Product Change Notification

109443 - 00

Change Notification #:	**109443 - 00**
Change Title:	**Intel(R) Hot-swap Backplane Kit AXX6DRV3GEXP, PCN 109443-00, Product Design, Add Mylar around the PCB mounting hole**
Date of Publication:	**June 29, 2009**

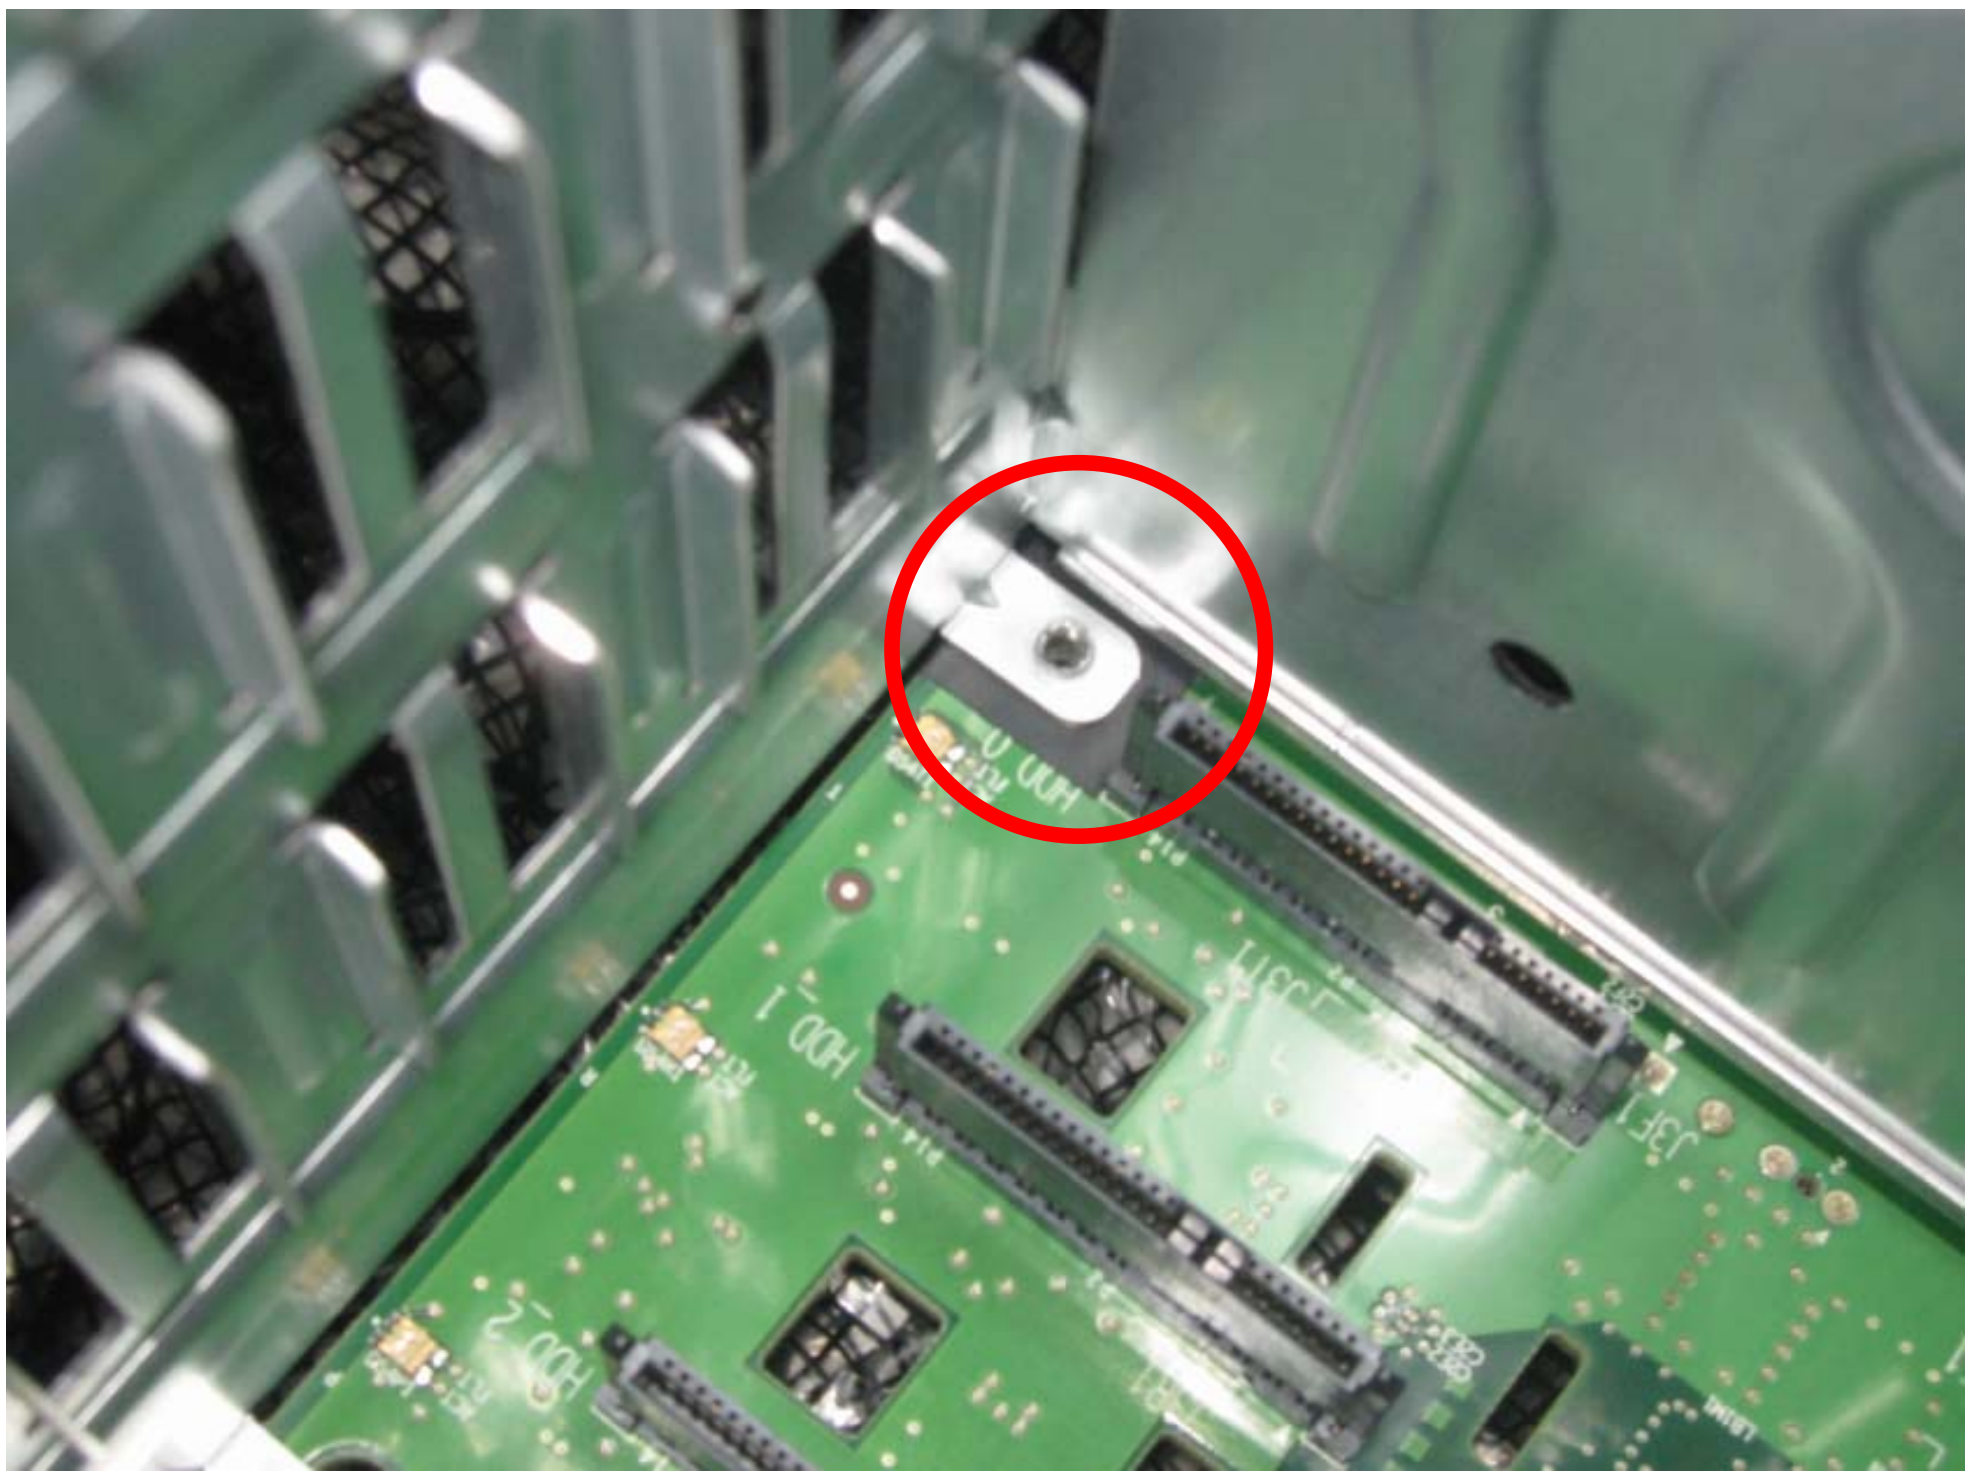
Intel factory will add Mylar between the backplane PCB (Printed Circuit Board) and the cage sheet metal, around the PCB mounting hole near HDD (Hard Disk Drive) slot 0 in order to increase mechanical separation and electrical insulation. Please refer to the following photo for the Mylar pad location.
